WATER PERMIT NO. 1671-1

SOUTH DAKOTA
WATER PERMIT NO. 1671-1

P & S Review | 6/29/98 TGS

Water Permit Application No. 1671-1
Bureau of Land Management

NRCS Annual Yield

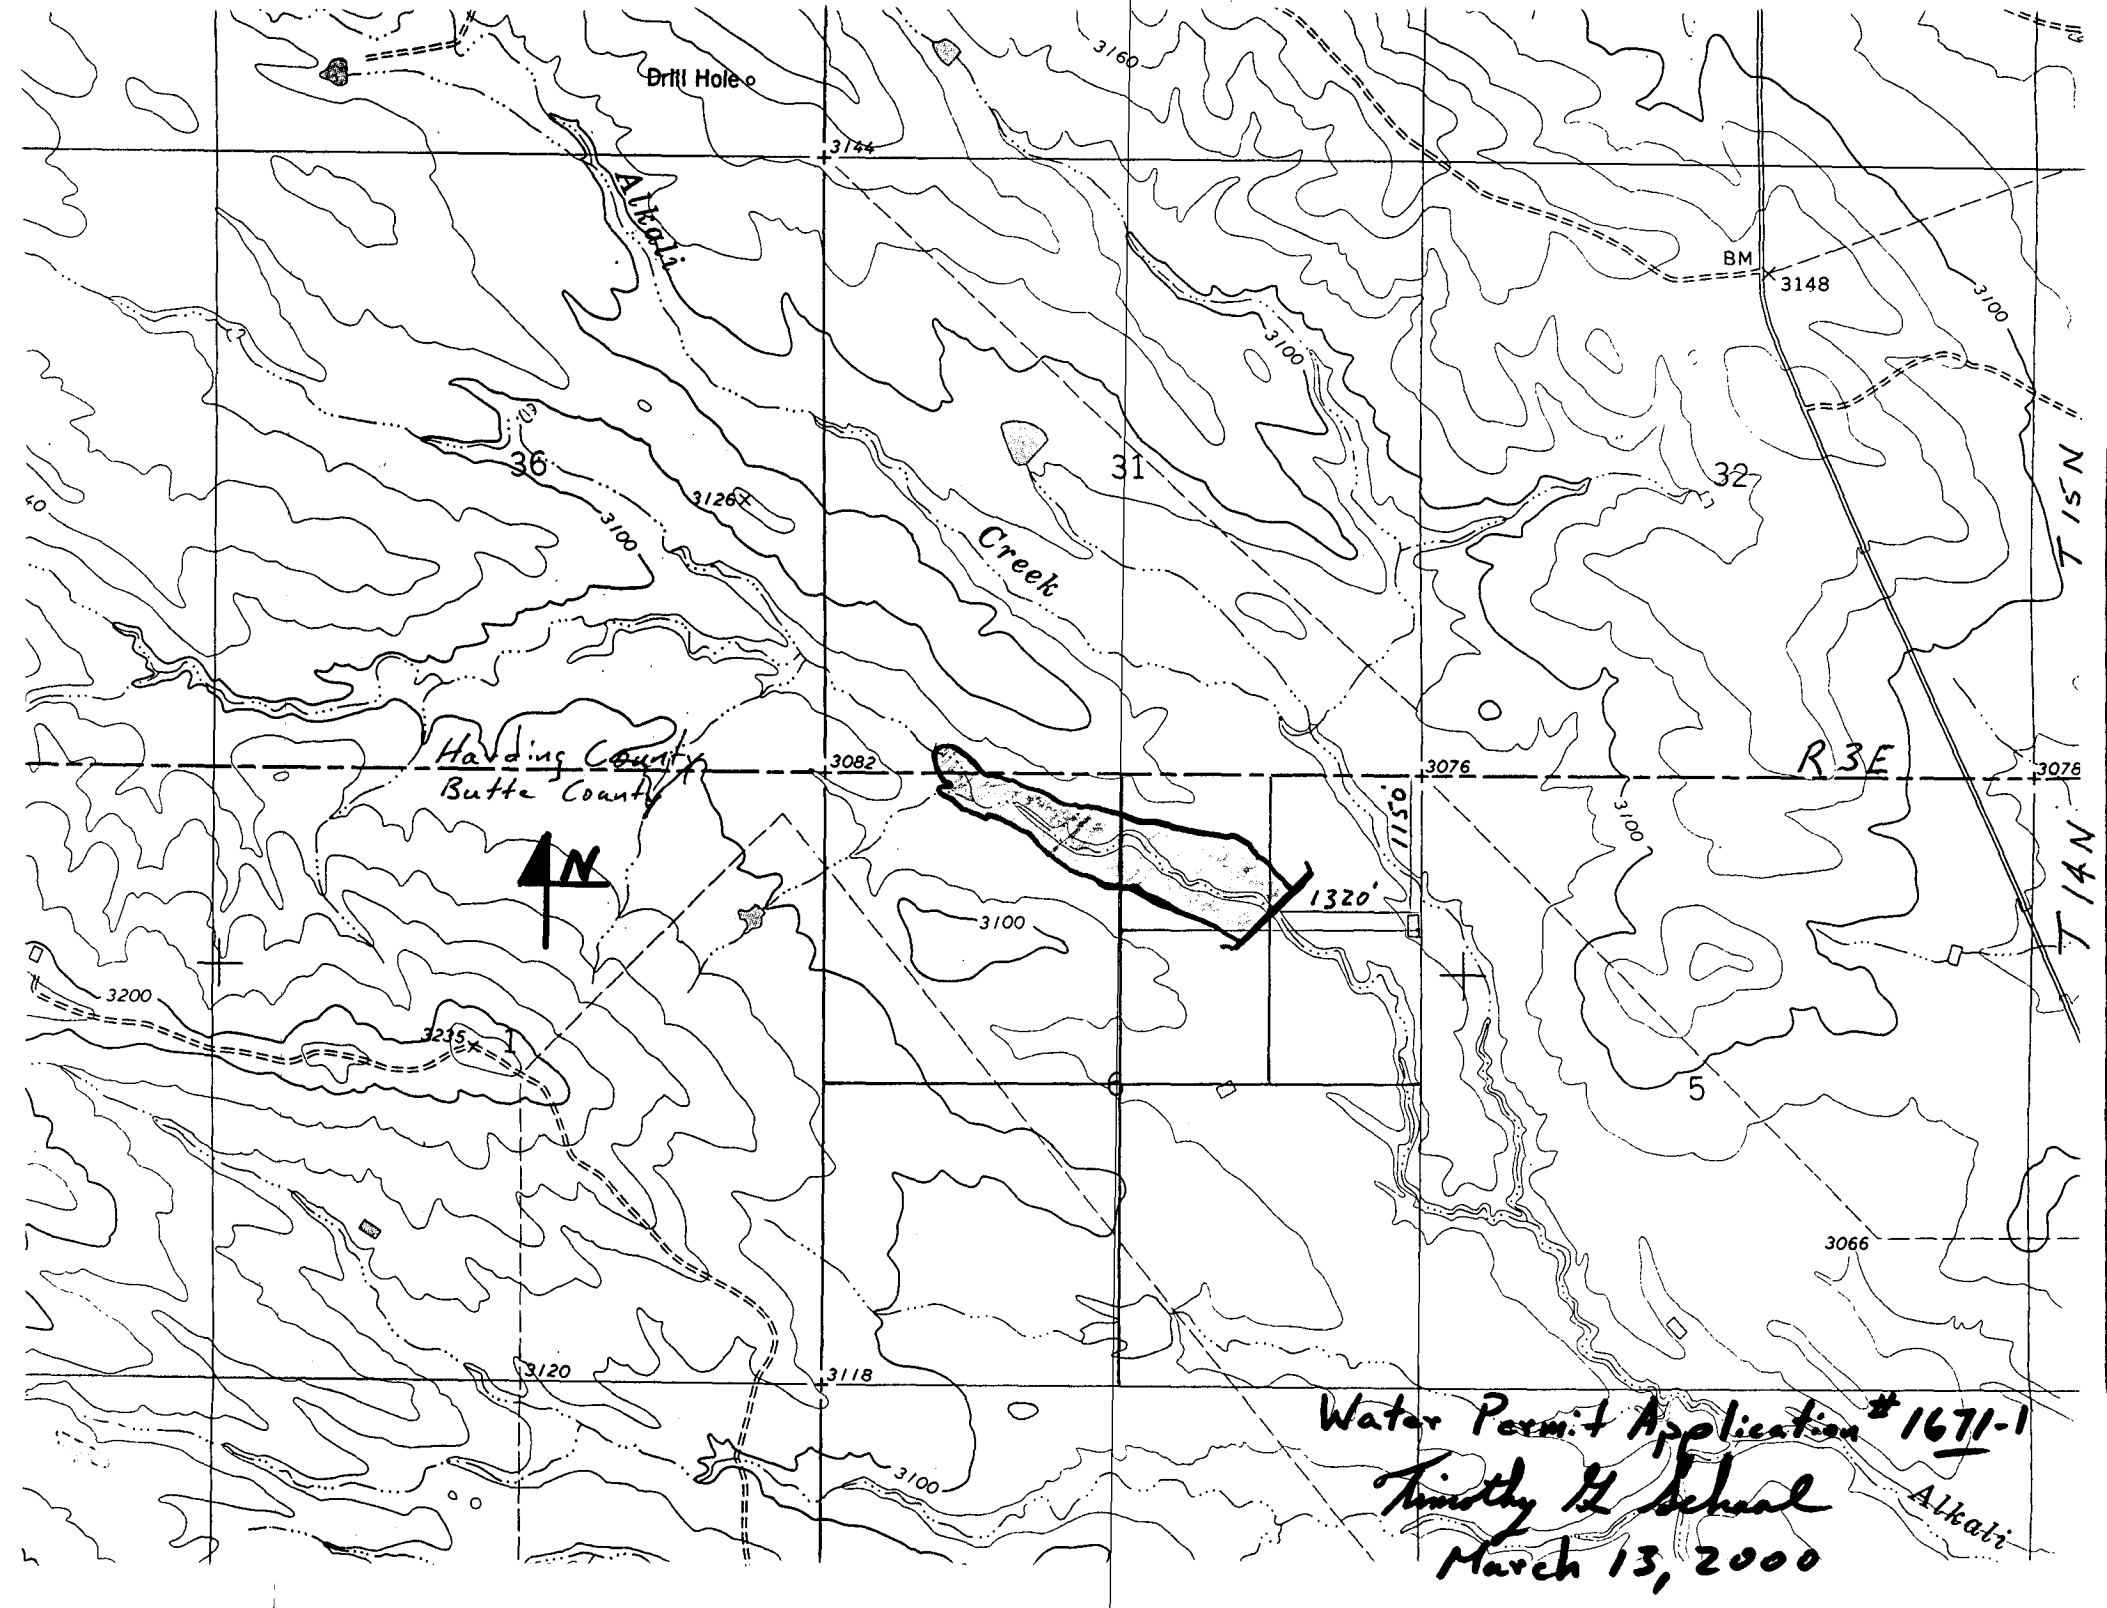
DA = 4600 Ac CN = 78 ISD = 1

80% chance = 0.08
$0.08 \times 4600/12 =$ 31 Ac-Ft.

50% chance = 0.25
$0.25 \times 4600/12 =$ 96 Ac-Ft.

10% chance = 1.3
$1.3 \times 4600/12 =$ 500 Ac-Ft.

The annual yield for this drainage area with a 10 percent chance of occurrence, or 1 out of 10 years, is expected to be 500 acre-feet. The annual yield with a 50 percent chance of occurrence, or 1 out of 2 years, is expected to be 96 acre-feet and the annual yield with a 80 percent chance of occurrence, or 8 out of 10 years, is expected to be 31 acre-feet.
